# METROPOLITAN GOVERNMENT OF NASHVILLE AND DAVIDSON COUNTY

## STAFF RECOMMENDATION 1407 Holly Street April 15, 2015

**Application:** New construction—addition  
**District:** Lockeland Springs-East End Neighborhood Conservation Zoning Overlay  
**Council District:** 06  
**Map and Parcel Number:** 08309043400  
**Applicant:** Jamie Day  
**Project Lead:** Melissa Baldock, [melissa.baldock@nashville.gov](mailto:melissa.baldock@nashville.gov)

01 SITE PLAN

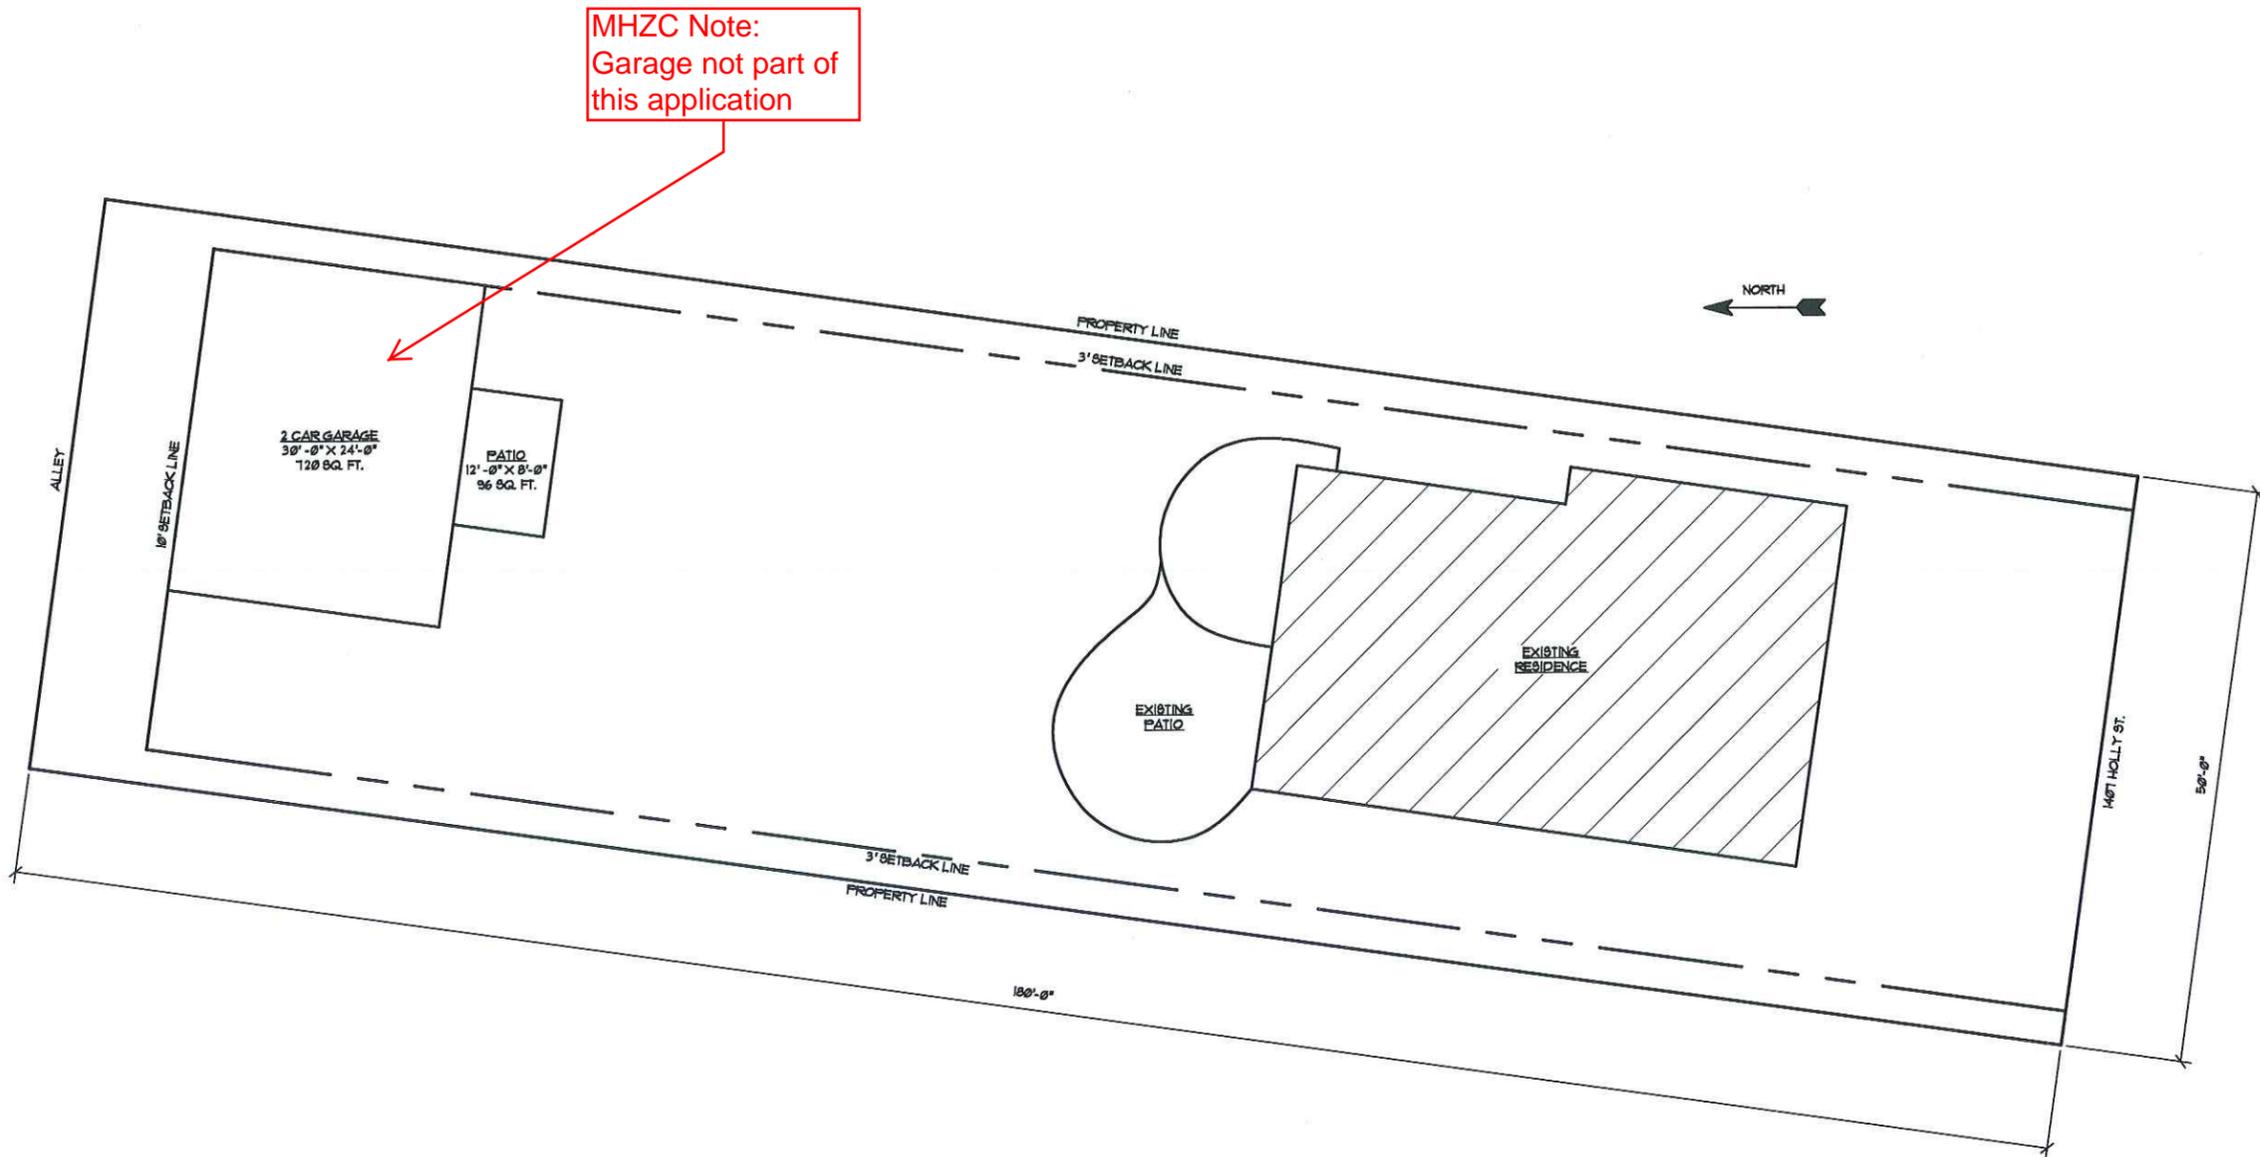
MHZC Note:  
 Garage not part of  
 this application

01 FRONT ELEVATION

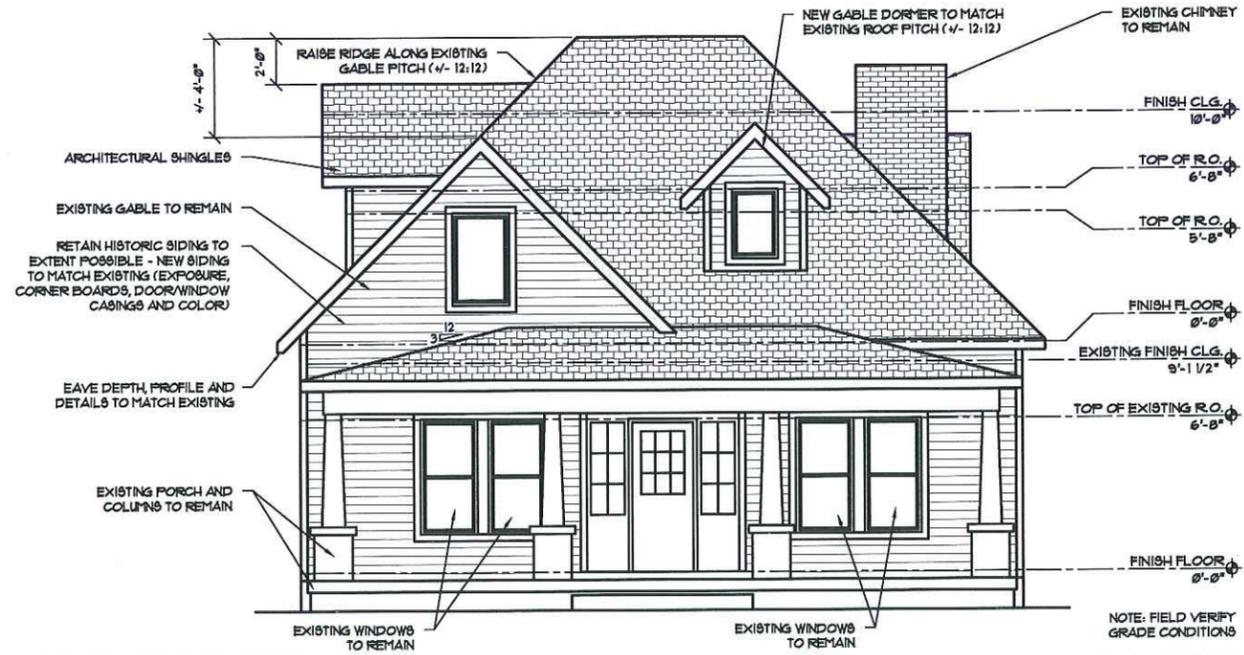
Partial Demolition. The project involves removing part of the non-historic roof form, which is appropriate. In addition, several window openings will be altered. On the front elevation, in the gable field, an existing vent will be enlarged to a window opening. On the east elevation, two existing window openings will be removed. Staff finds their removal to be appropriate because they are located on a portion of the wall that was not part of the historic house. On the west elevation, the applicant is proposing to alter two existing window openings. Staff finds this to be acceptable, even though they are part of the original house, because they are located beyond the midpoint of the side façade. Staff finds that the project meets Section IV.2. for appropriate demolition and does not meet Section IV.1. for inappropriate demolition.

Roof Shape: The non-historic hipped roof at the front of the house will be raised in height by two feet (2'). The slope of this portion of the roof will not change. A new front dormer will be added to this non-historic roof form. Although front dormers are typically not permitted in the Lockeland Springs-East End Conservation Zoning Overlay, staff finds this dormer to be appropriate because it will be located on a non-historic roof form and its scale and location are compatible with the historic house. The dormer will be set more than two feet (2') off the roof ridge and more than two feet (2') from a valley. It will be inset two feet (2') from the wall below. It will have a gabled roof form, and its slope will be 12/12 to match the pitch of the hipped roof.

02 LEFT ELEVATION

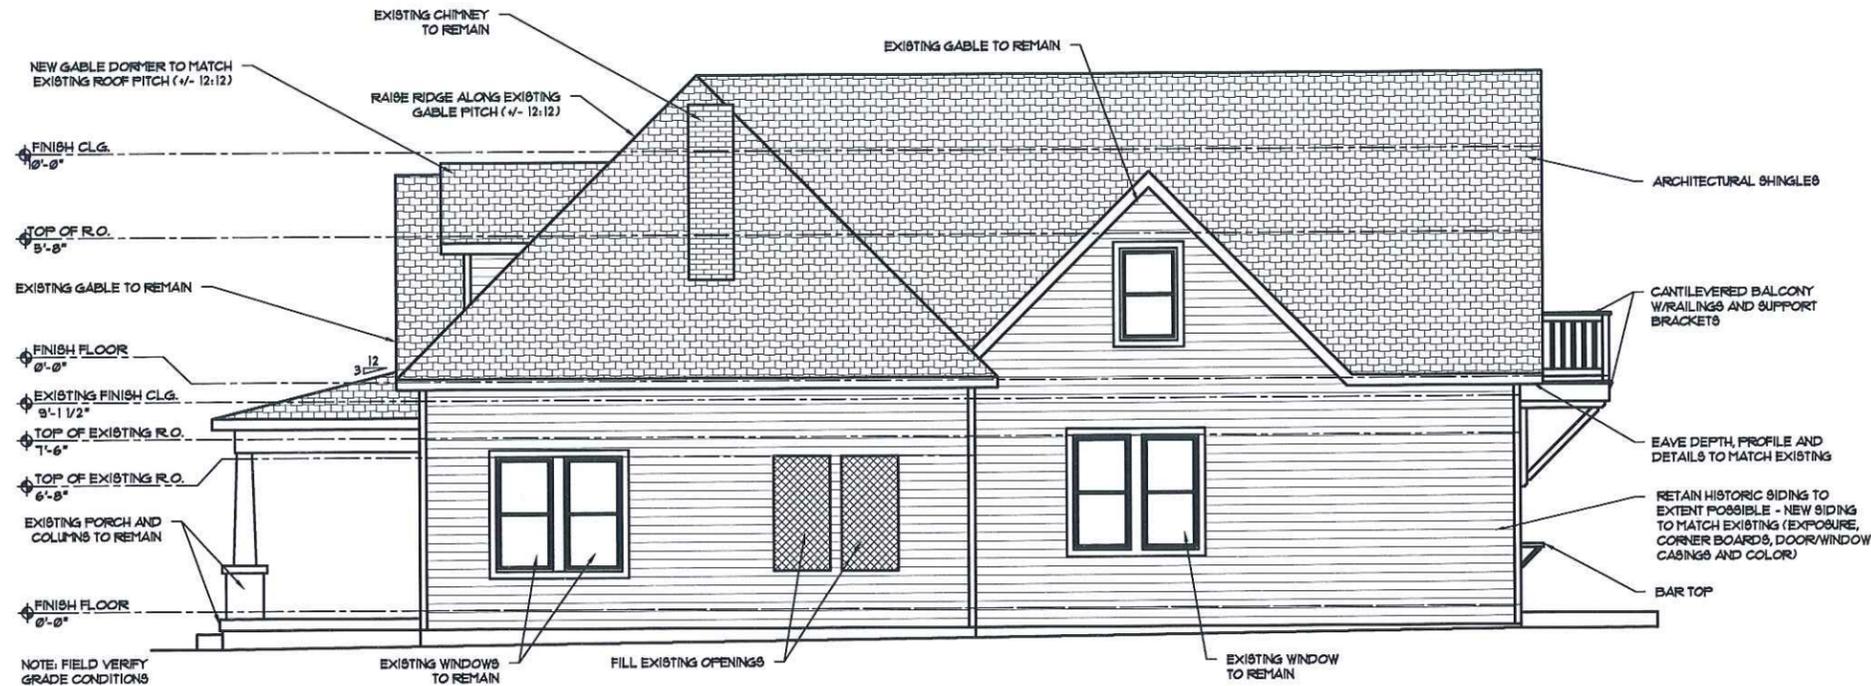
The addition of the side dormer on the left side, on the historic portion of the roof, will be constructed so that it sits off the ridge by two feet (2') and sits back from the wall below by two feet (2'). As such, it will not overwhelm the historic roof and could be removed in the future without detrimentally affecting the historic character of the house. Staff finds that the addition meets Section II.B.10. of the design guidelines.

A new gable roof form will tie into the back of the non-historic hipped roof. This gable will have a slope of 12/12, and it will allow the historic side gable on the east side to remain. On the west elevation, the applicant is proposing a new side dormer. The side dormer will be located on the back portion of the roof, behind the hipped roof form, and will be located two feet (2') off the ridge, two feet (2') from the side wall, and two feet (2') back from the wall below. Its roof form will be two 12/12 gables connected with a shed roof form.

Orientation: The house's orientation towards Holly Street will not be altered as part of this project. A new, secondary side entry will be added on the west elevation. Staff finds this to be appropriate because it is located at about the midpoint of the historic house and will read as a secondary side entrance. Staff finds that the project's orientation meets Section II.B.6. of the design guidelines.
